ADDENDUM NO. 1

**ARCADIA HIGH SCHOOL
LOCKER ROOM ALTERATION
ARCADIA UNIFIED SCHOOL DISTRICT**

tBP/ARCHITECTURE
4611 Teller Avenue
Newport Beach, CA 92660
949-673-0300

This Addendum forms a part of the Contract Documents and modifies the original Bidding Drawings dated August 15, 2024, and Specifications dated July 2024. Acknowledge receipt of this Addendum in space provided on the Bid Form. Failure to acknowledge may subject Bidder to disqualification.

drawing title:
MECHANICAL BLDG. BL
- FLOOR PLANS

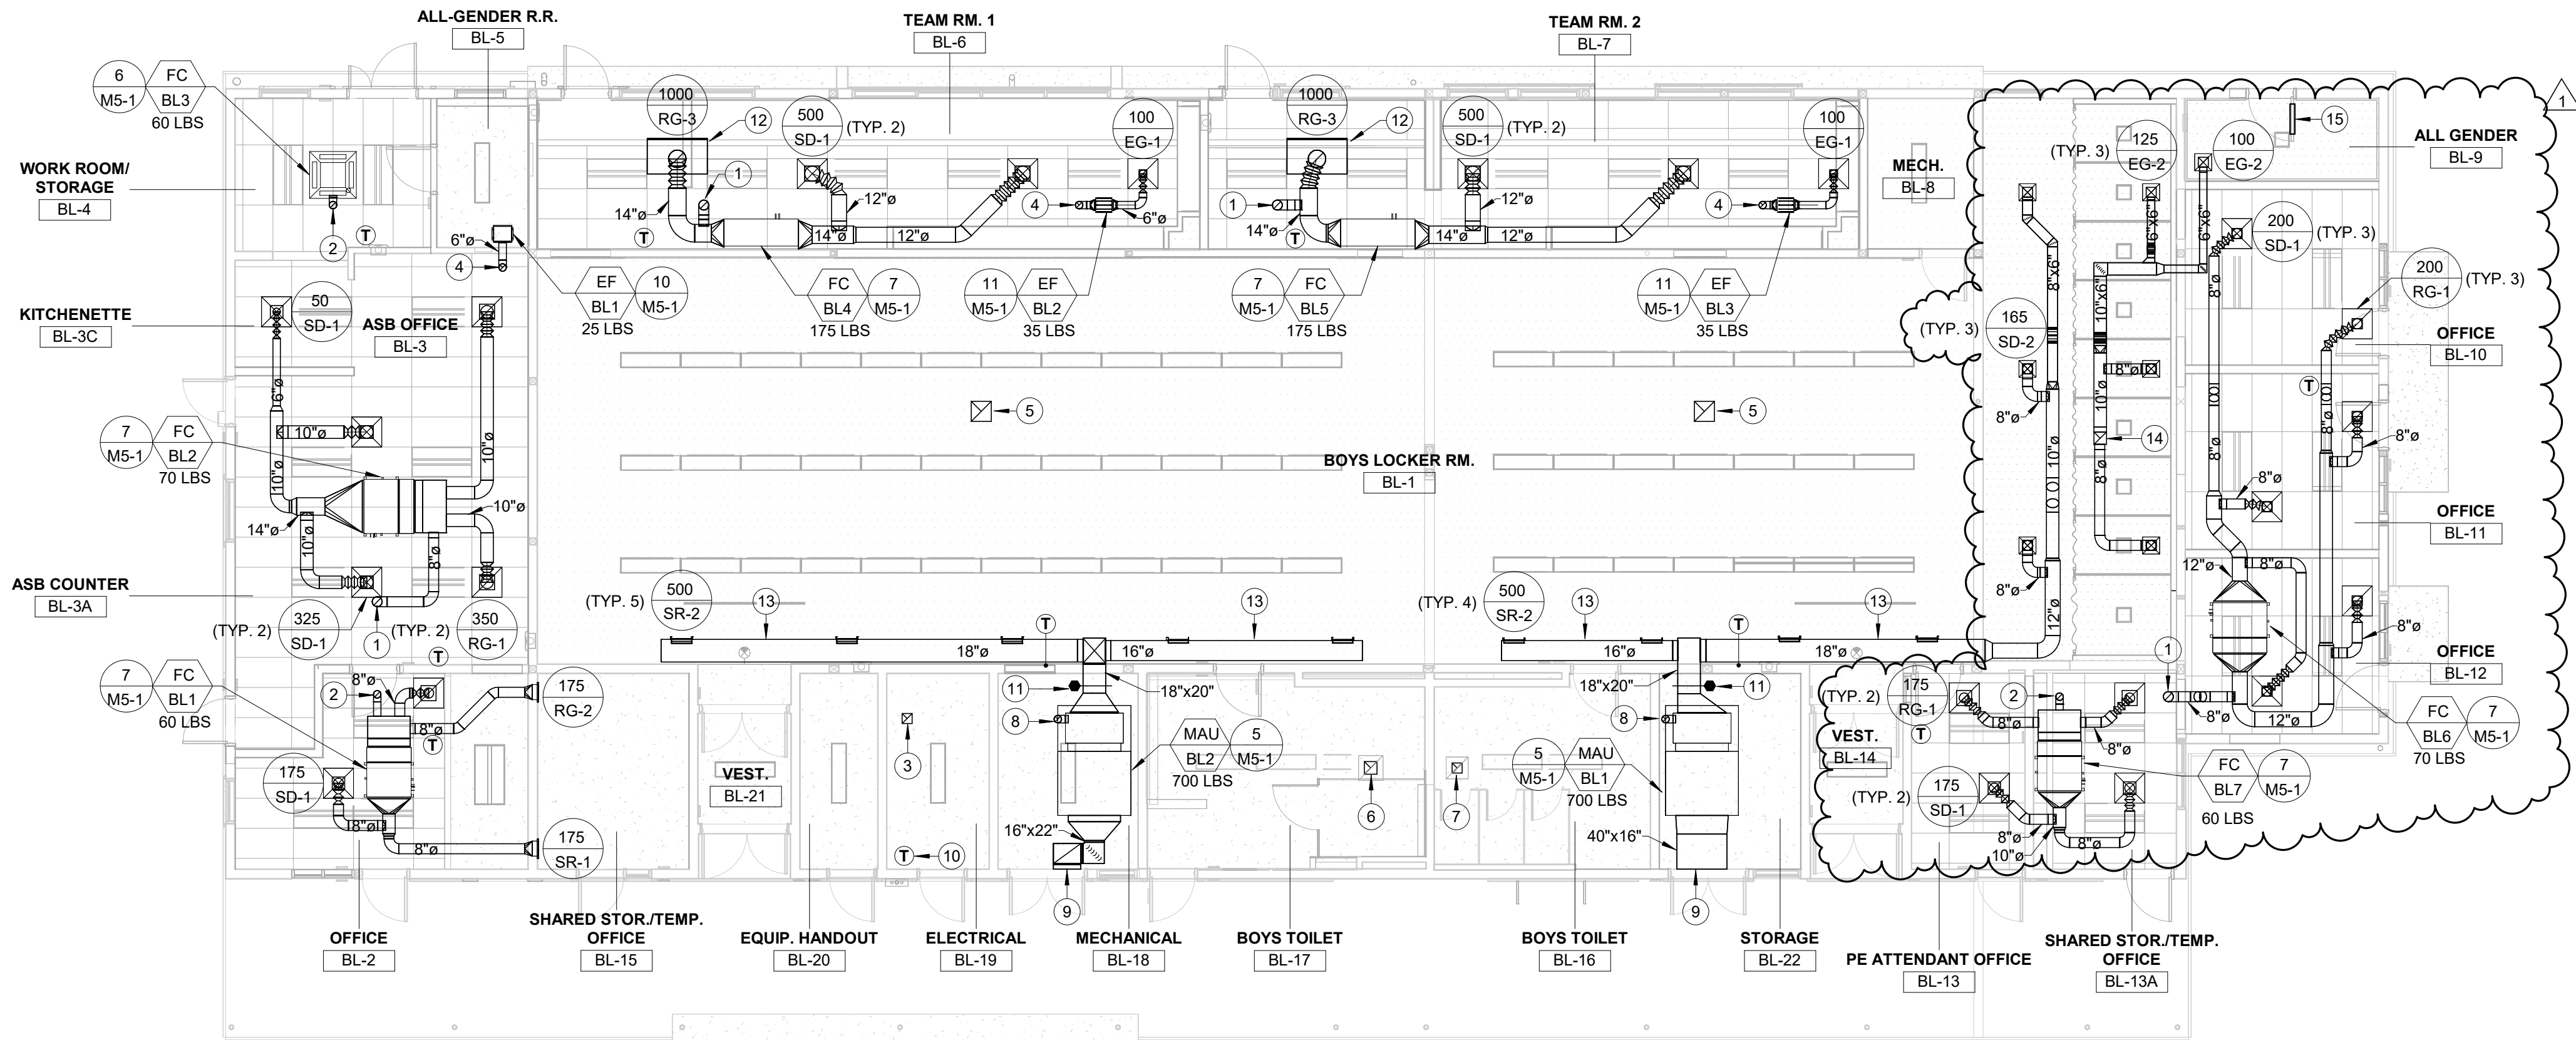
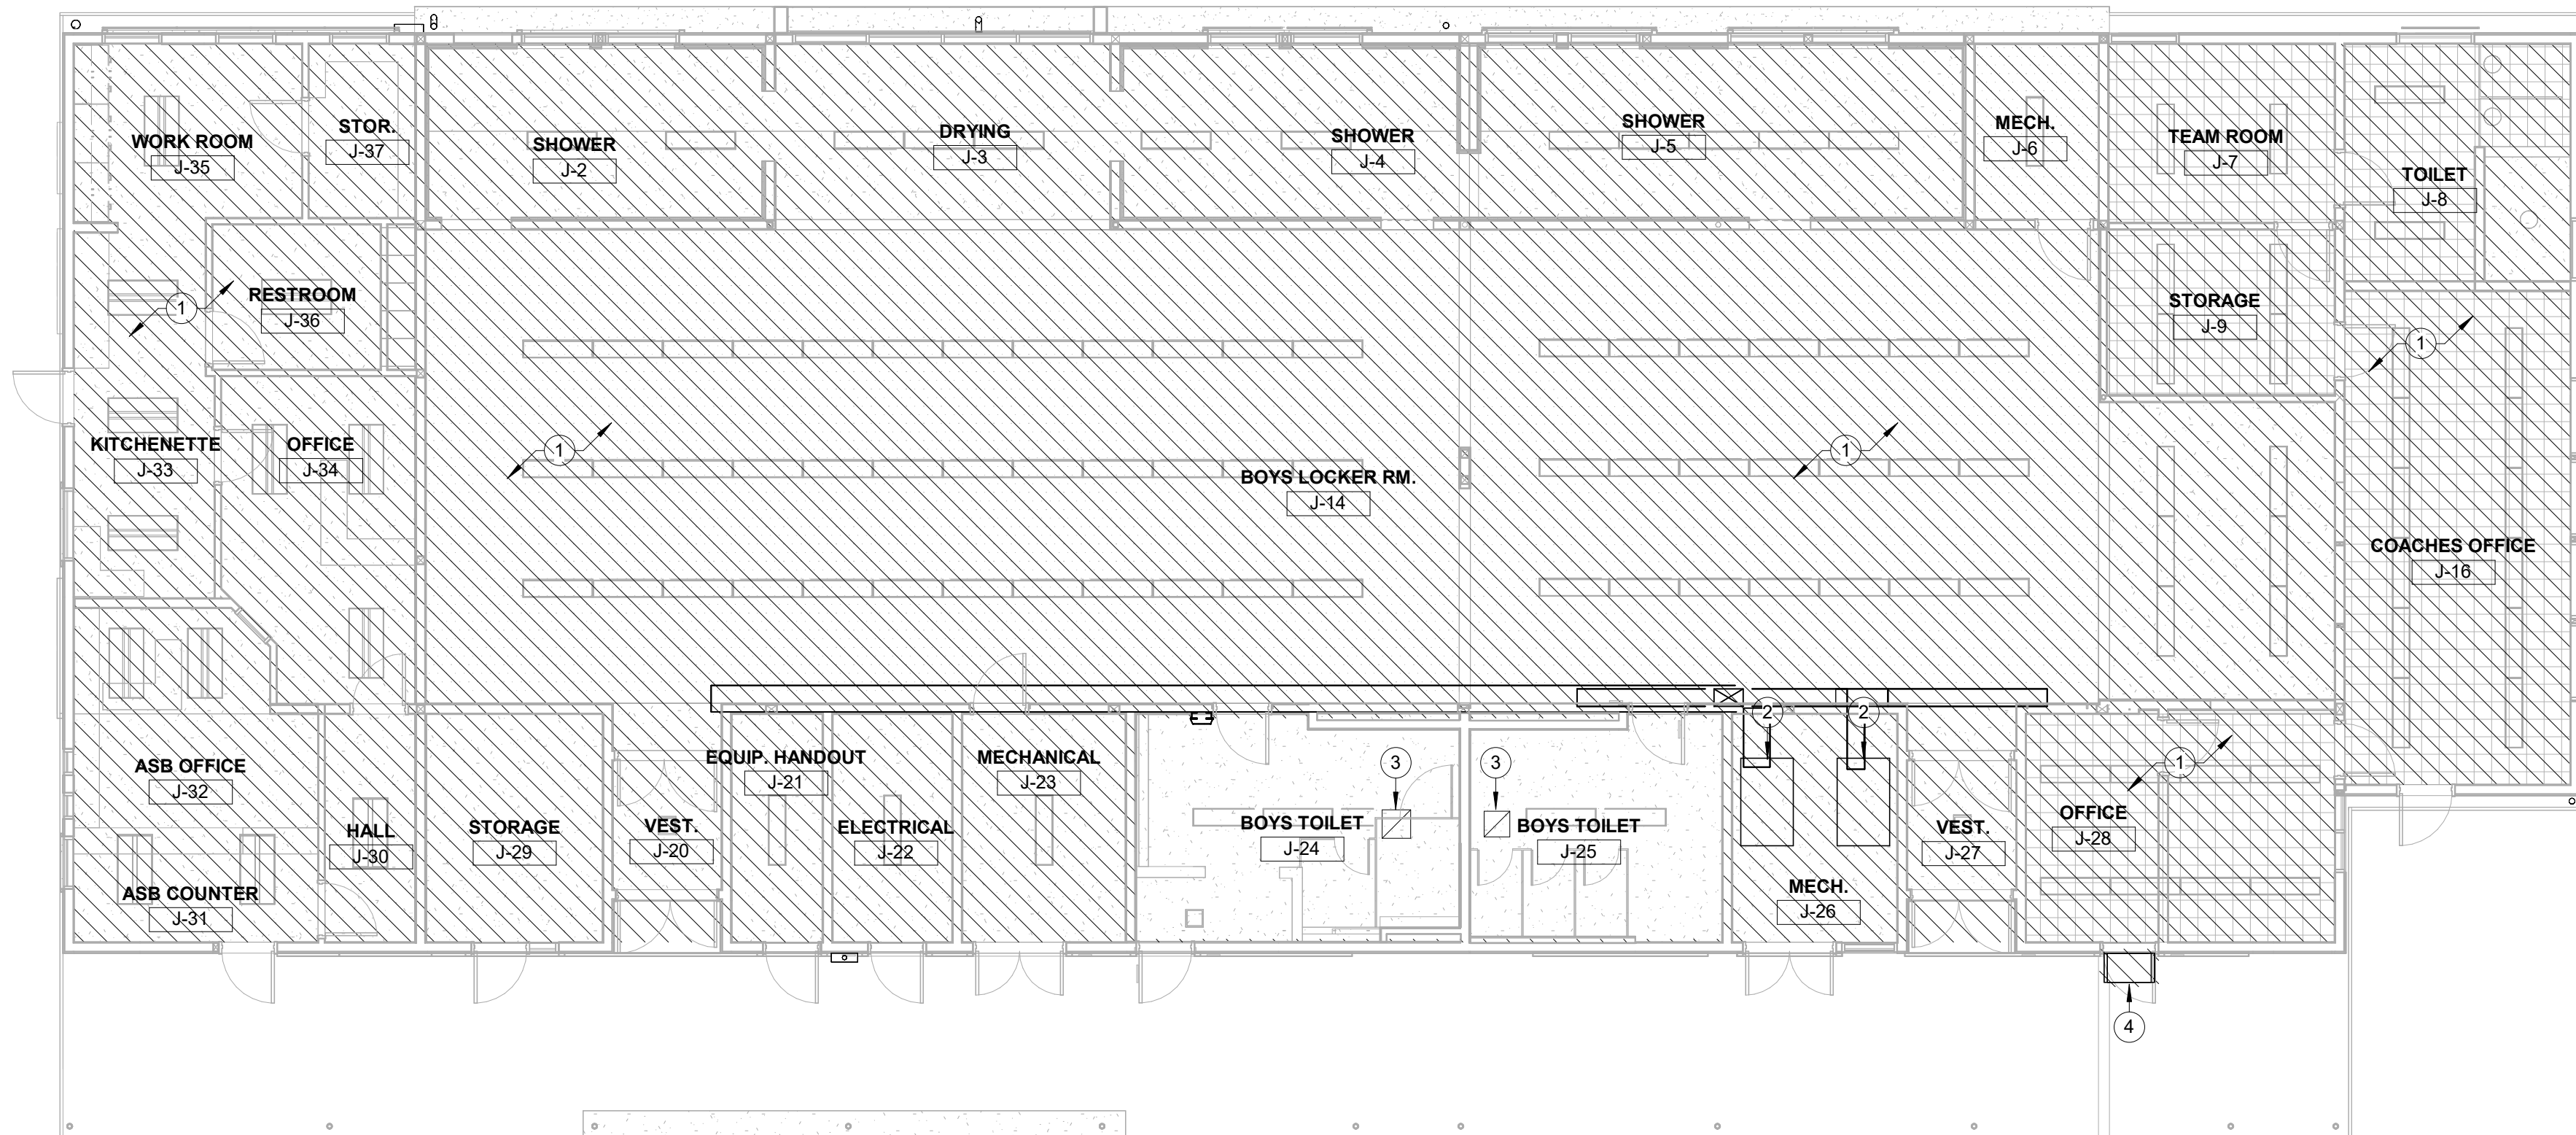
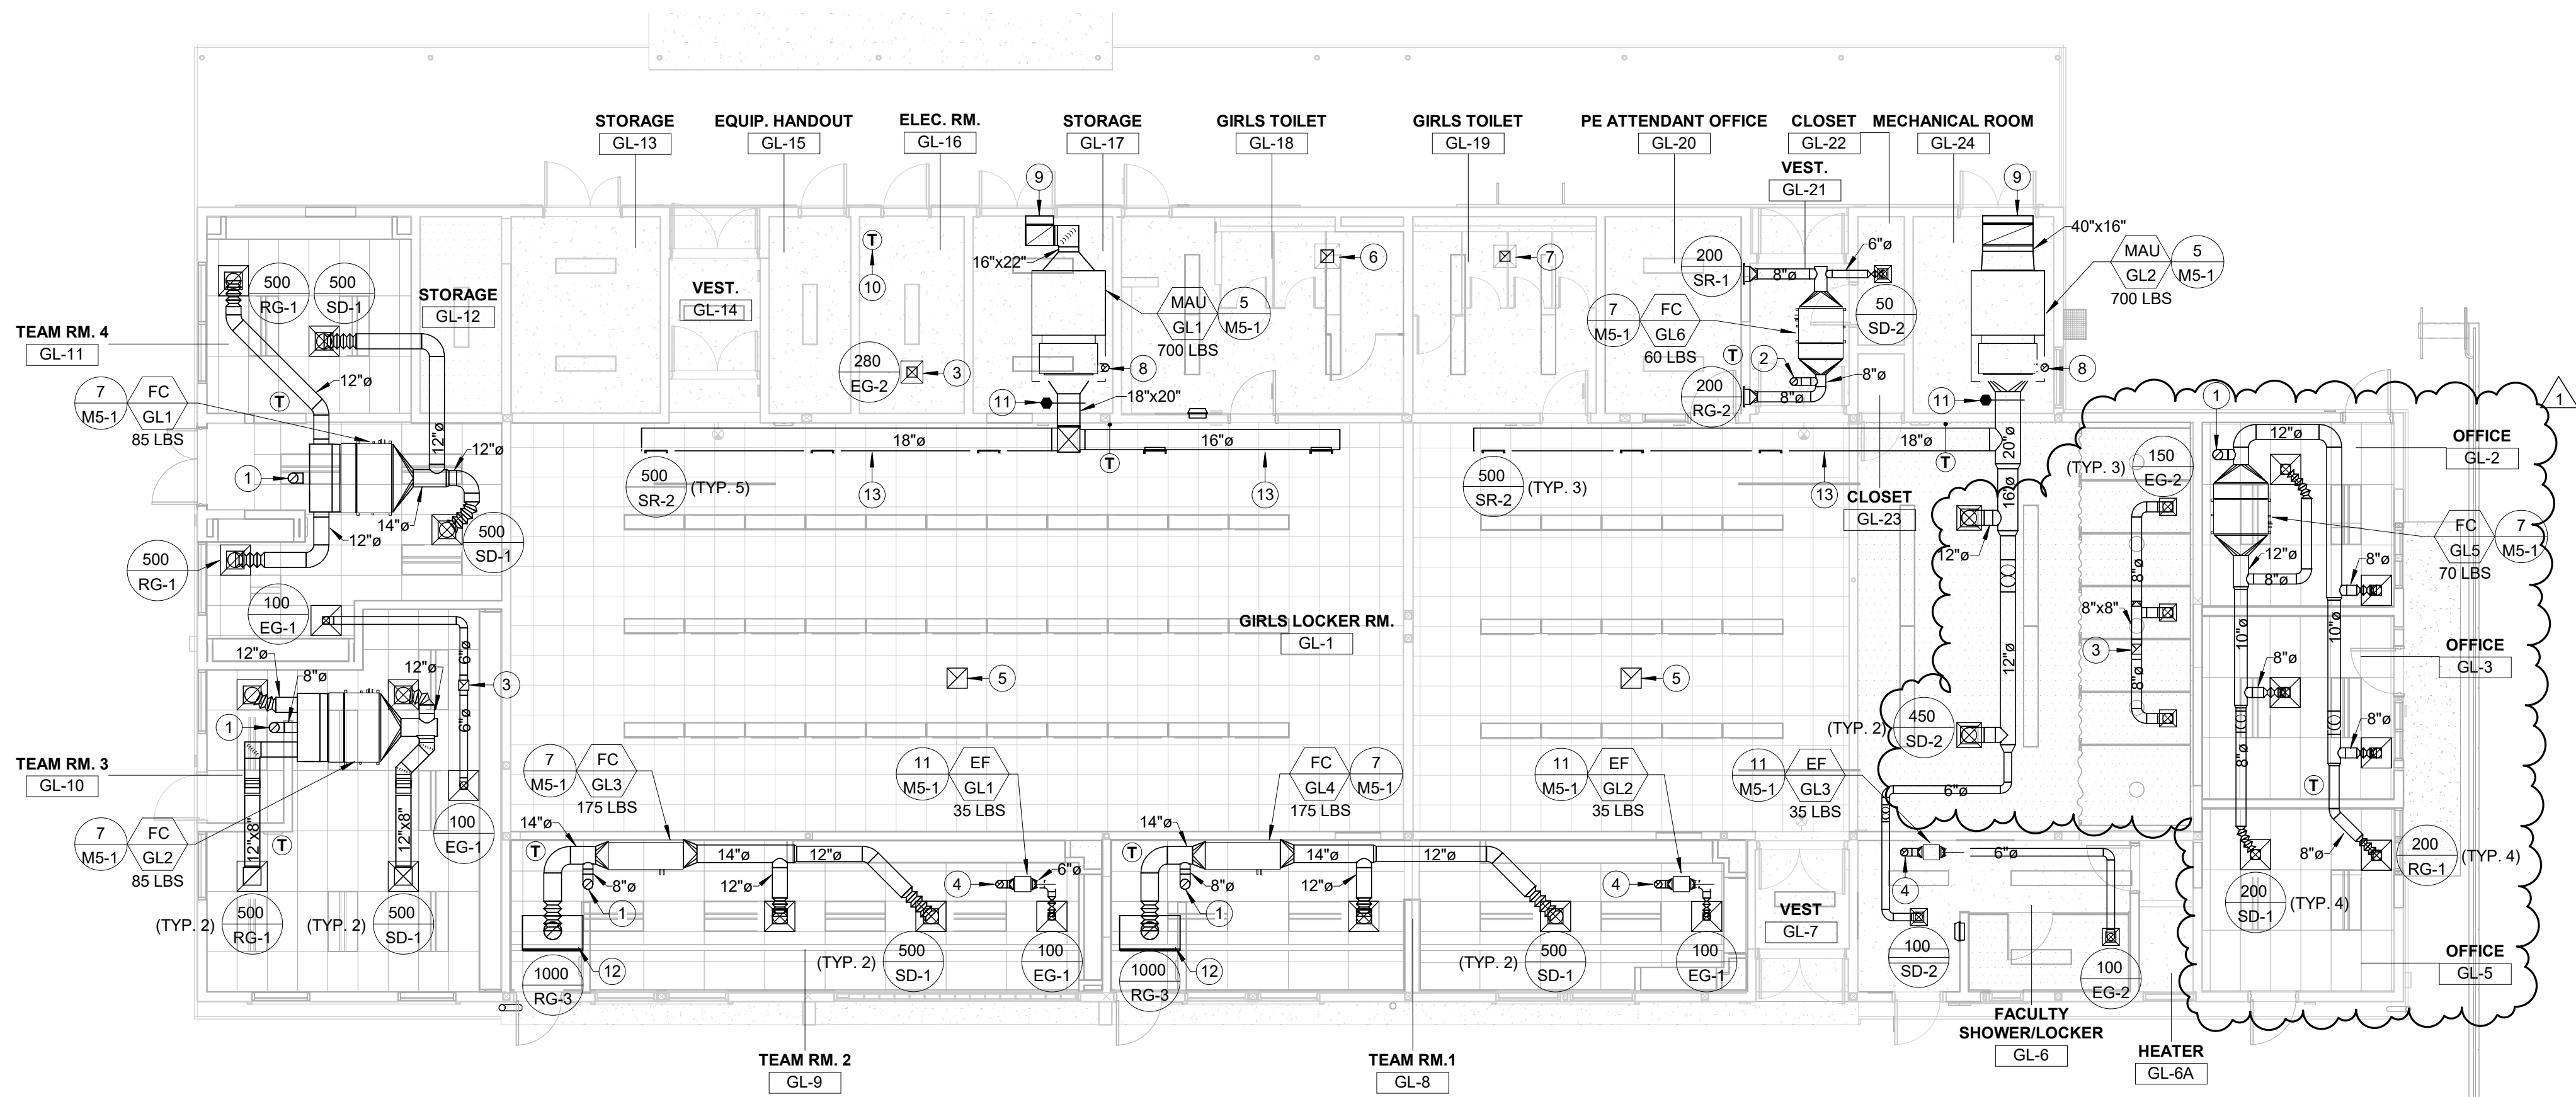
- b. Relocate mechanical registers in Offices in accordance with architectural plan.
 - c. Add louver to existing door at All Gender Restroom, BL-9.
- 22. SHEET M2-2 – MECHANICAL BUILDING GL – FLOOR PLANS
Replace full size sheet drawing **M2-2** in its entirety, issued with this addendum.
Changes include:
